Minta Farm
Amendment C269
Expert Evidence – Traffic & Transport

190315PAN001C-F

3 April 2020

Drawing Title
 MINTA FARM
 INTERSECTION IN-02 (ONE MILE GRID DESIGN)
 CONCEPT LAYOUT PLAN - ULTIMATE

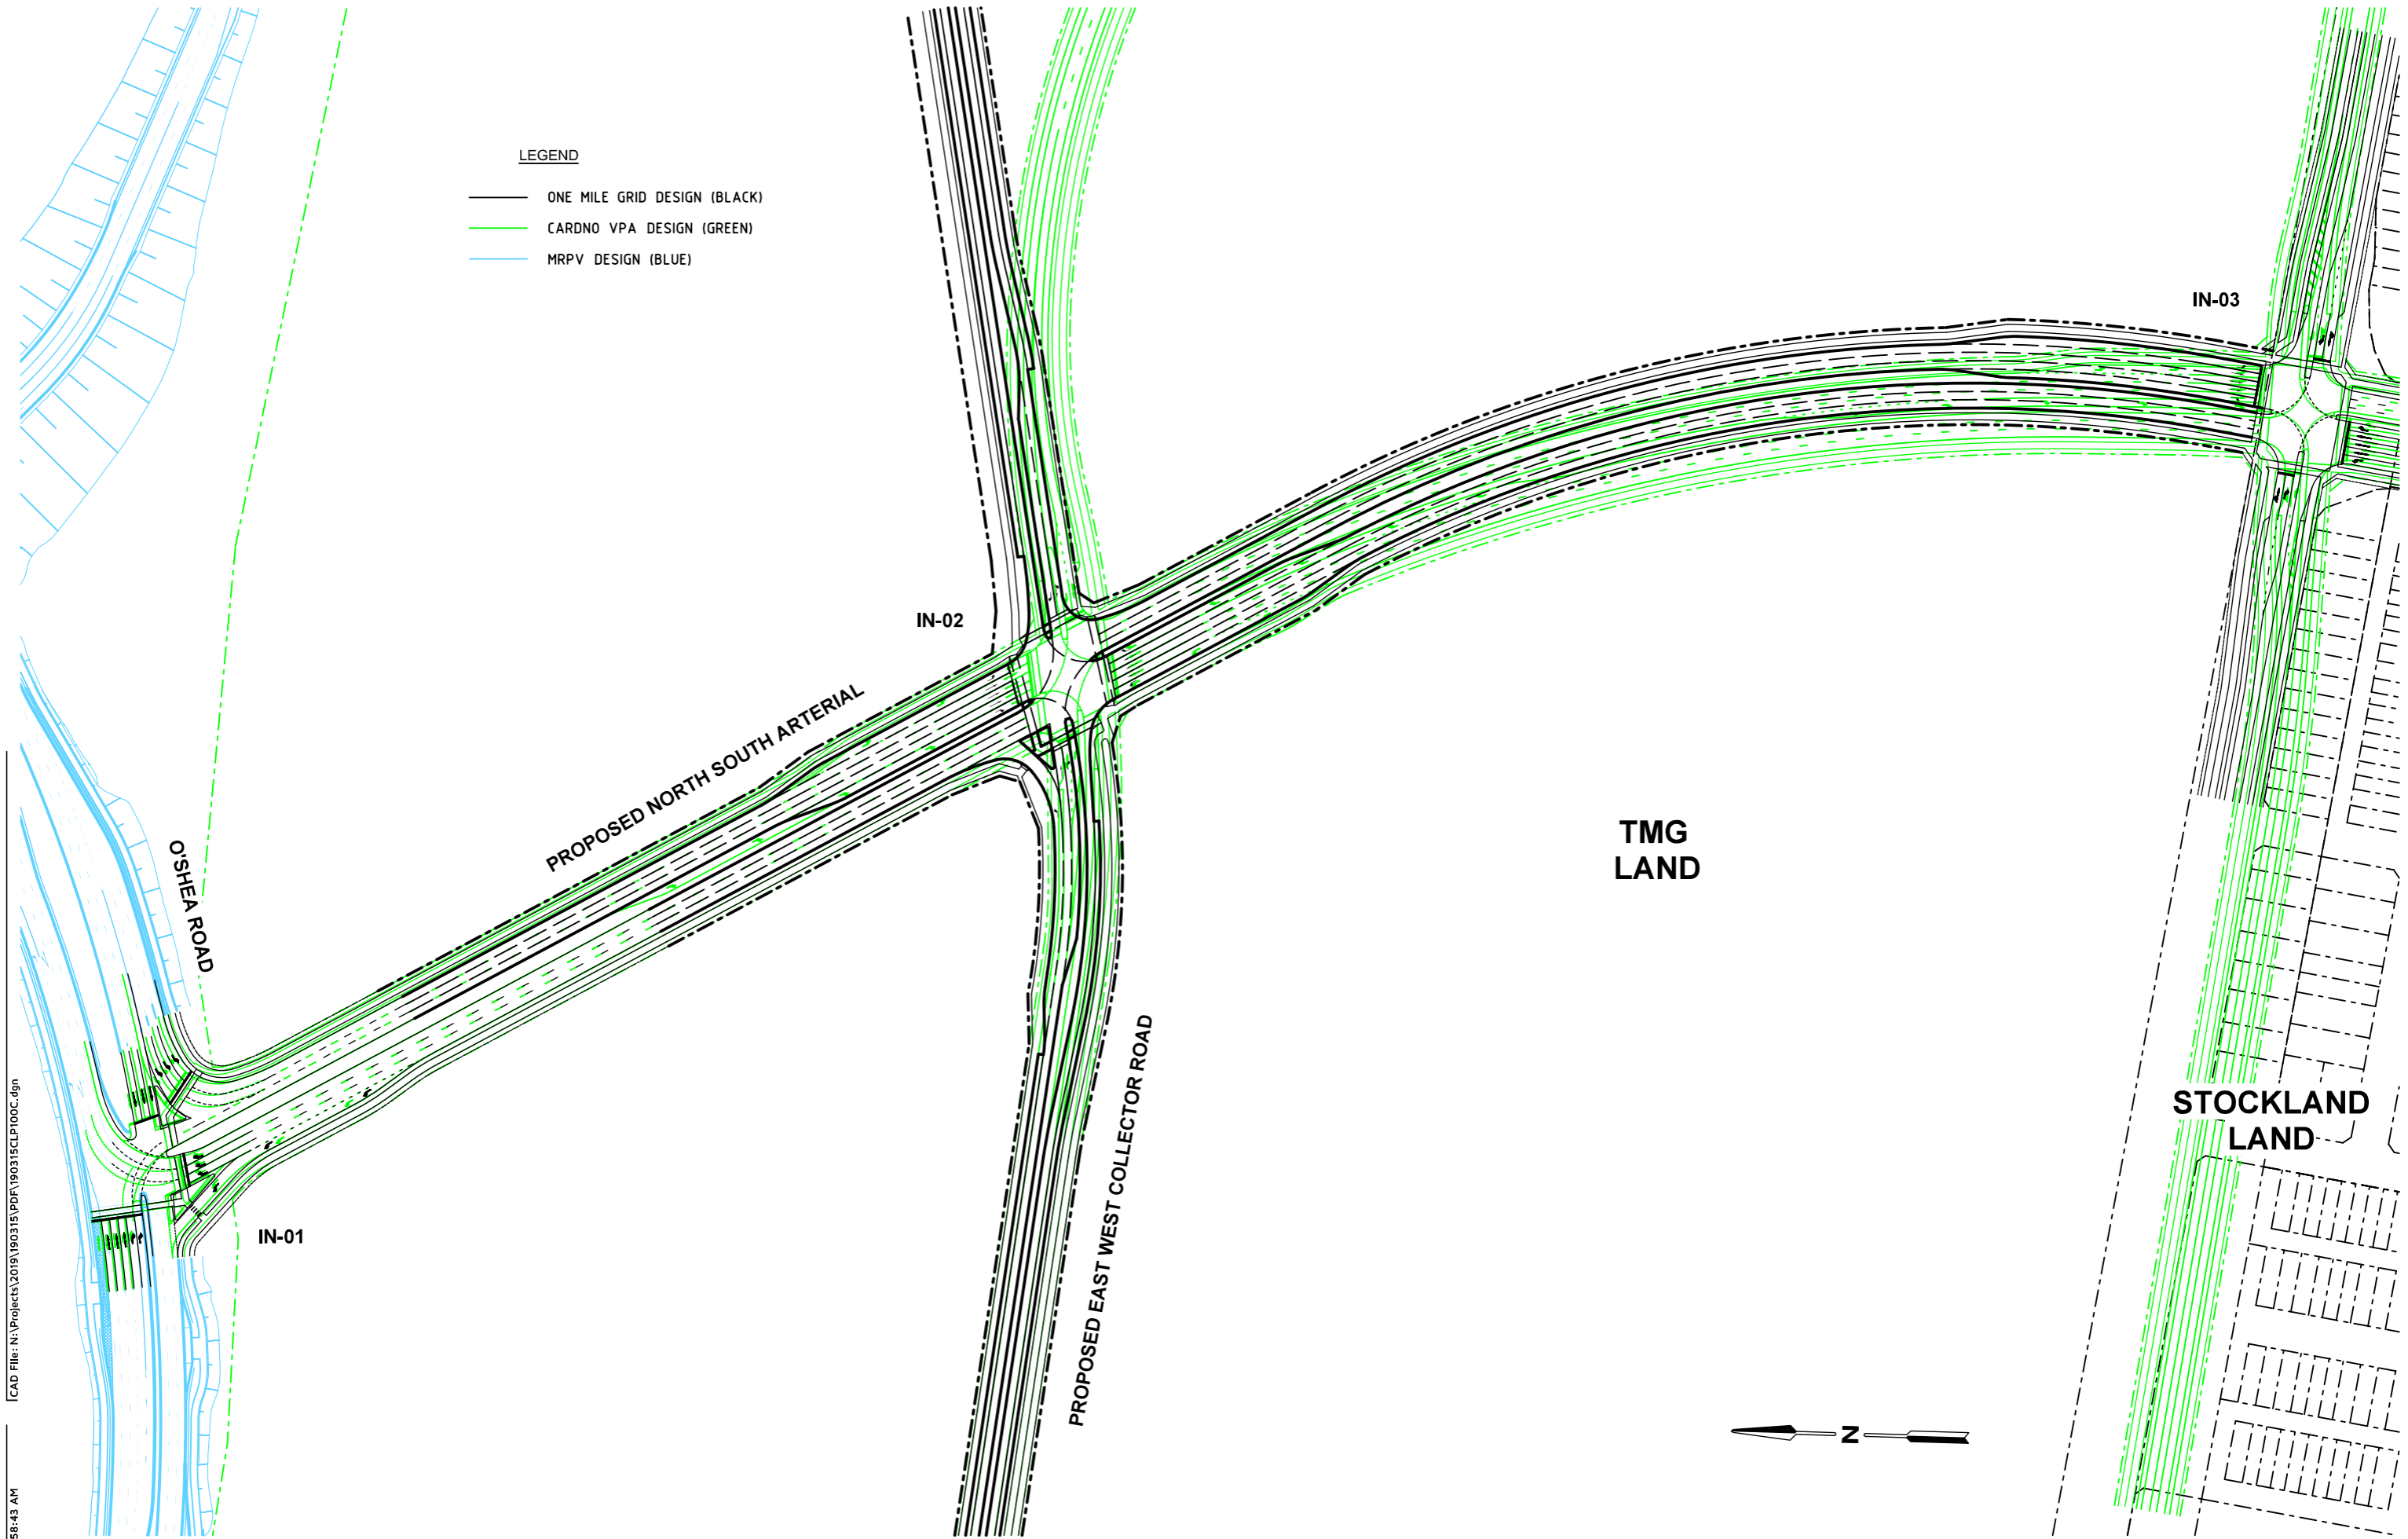
I have recommended modifications to the intersection orientation for IN-02 to provide for a more conventional intersection arrangement. Effectively, my review has removed the radius which was applied through the intersection in both directions and instead provided a straight which allows for improved approaches to the intersection and sightlines.

I note that the PSP design includes a left turn slip lane on the northwest corner of the intersection from the collector road to the arterial. As this intersection is located within a local town centre and commercial precinct, typical practice to promote pedestrian safety is not to provide slip lanes due to the potential vehicular / pedestrian conflicts. The slip lane should therefore be removed.
